LINCOLN PARK PLANNING COMMISSION
SPECIAL MEETING
December 17, 2020 at 6 p.m.

3387 Fort – Plumbing Contractor

Site Plan Review

Applicant	Tracey Yarbrough
Project	Plumbing Contractor
Address	3387 Fort Street, Lincoln Park, MI 48146
Date	December 17, 2020
Request	Site Plan Review
Recommendation	Approval with Conditions

S-1

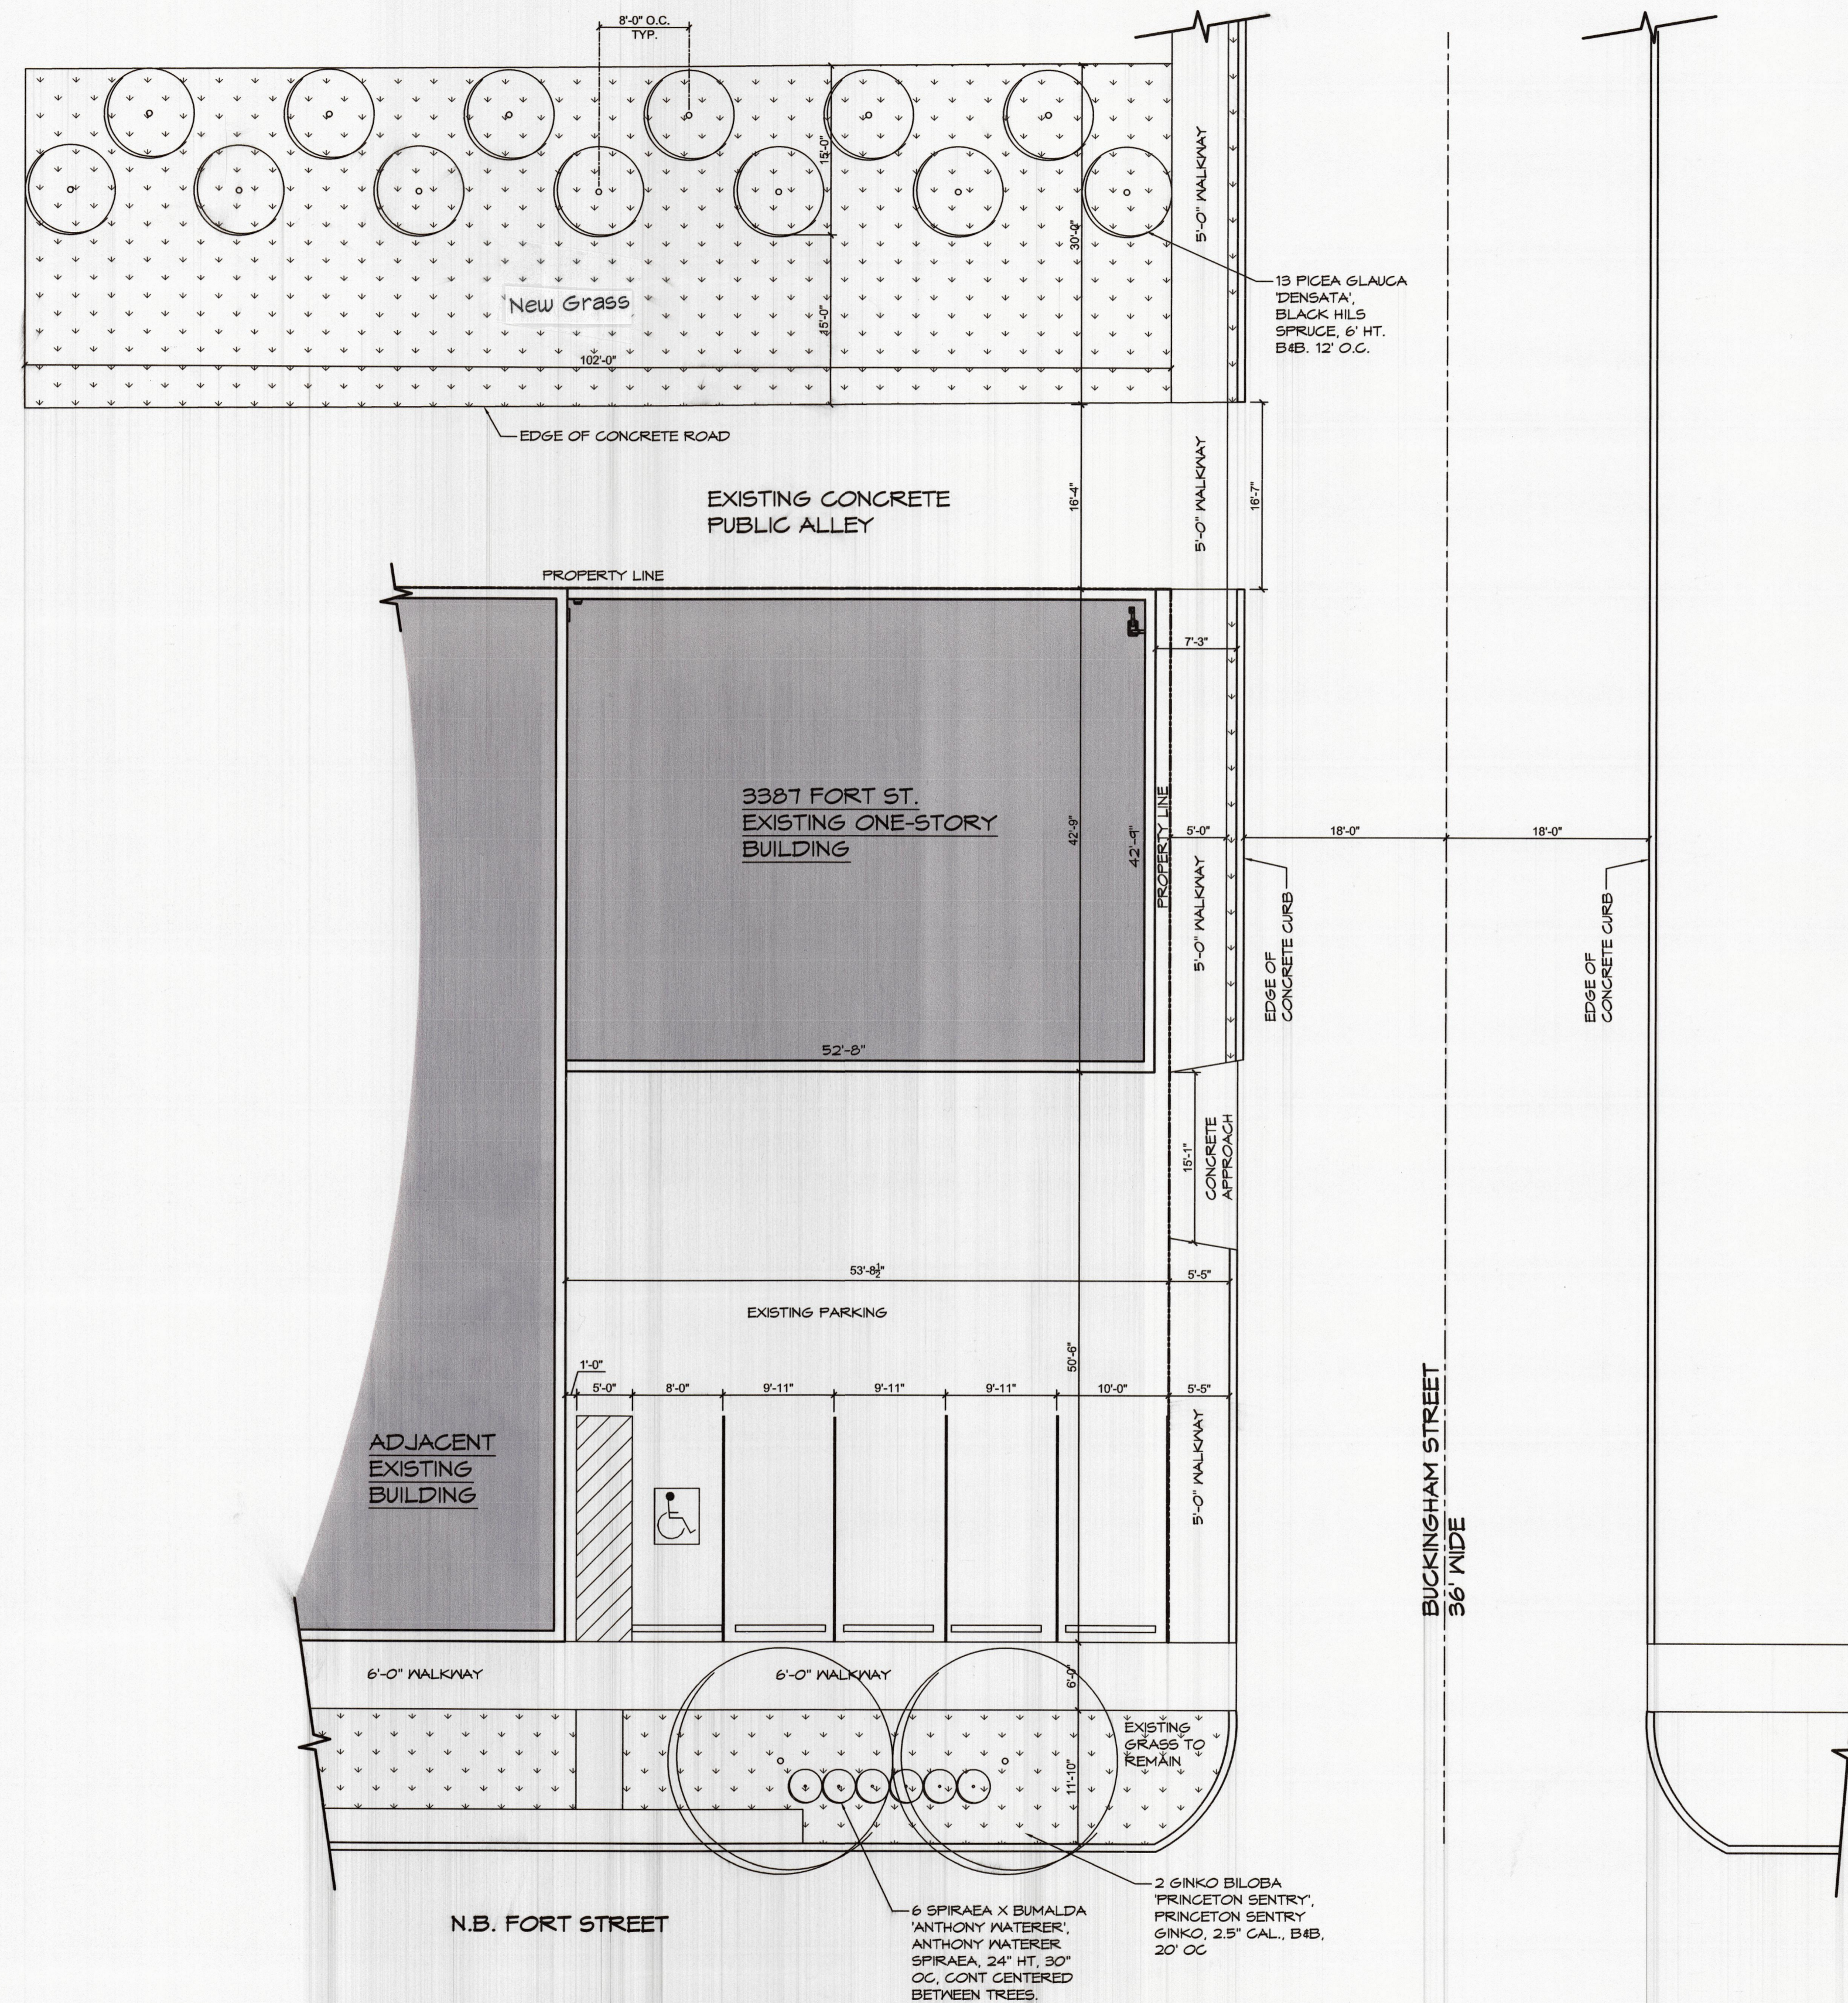
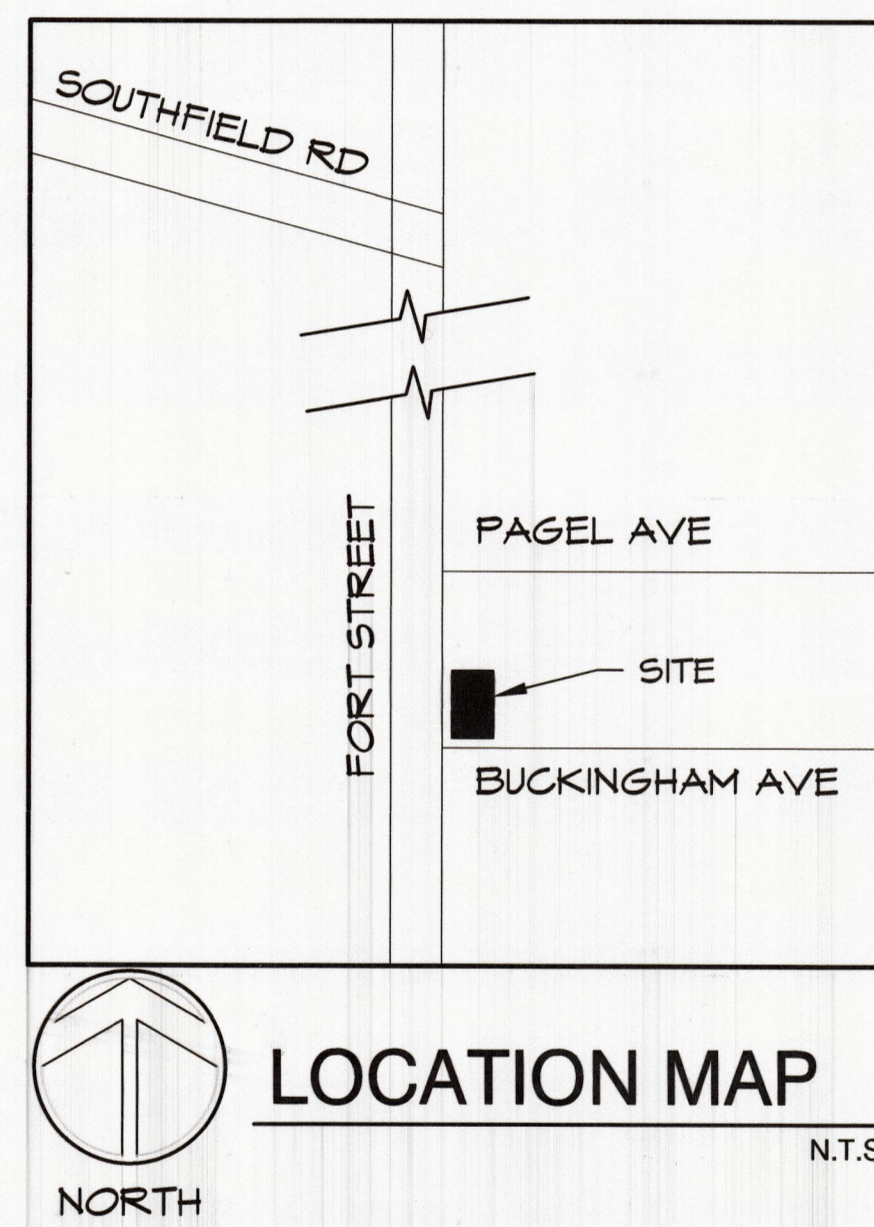
The site is served by a 6' public sidewalk along Fort Street and 5' sidewalks along Buckingham and Pagel Avenues, which provides pedestrian circulation separated from the vehicular circulation. However, there is no internal sidewalk to connect pedestrians to the building. There are no bicycle lanes on the ROW or bicycle parking facilities proposed.

- Applicant shall ensure that concrete sidewalks are brought up to the City's standards.

- The existing asphalt parking area shall be resurfaced and brought up to the City's standards.*

Required	Proposed	Compliance
Street Landscaping	Greenbelt, 10' width minimum with groundcover	11' 10" grass area between sidewalk and Fort St. Sidewalk on Buckingham St directly abuts street with no space for landscaping. 2 proposed trees and 6 proposed shrubs along Fort Street frontage. Proposed shrubs provide obscuring hedge needed for Fort Street.	Met
	1 tree and 4 shrubs per 40' of street frontage <i>~60' street frontage = 2 trees and 6 shrubs required</i>		
	Where headlights from parked vehicles will shine into the ROW, may require a totally obscuring hedge		
Interior Landscaping	10% of total lot area landscaped, including groundcover	Not provided; lot is entirely covered by building, sidewalk, and parking	N/A
	Interior landscaping to be grouped near entrances, foundations, walkways, service areas		
	1 tree per 400 sf of required landscaping and 1 shrub per 250 sf of required landscaping

Parking Lot	1 deciduous or ornamental tree per 10 parking spaces <10	Not provided; lot is entirely covered by building, sidewalk, and parking.	N/A
	100 sf of planting area per tree		
Screening	Waste receptacle: Decorative masonry wall of at least 6' with solid or impervious gate	New waste receptacle is not proposed. Applicant proposes to share an existing dumpster with a neighboring tenant.	Met
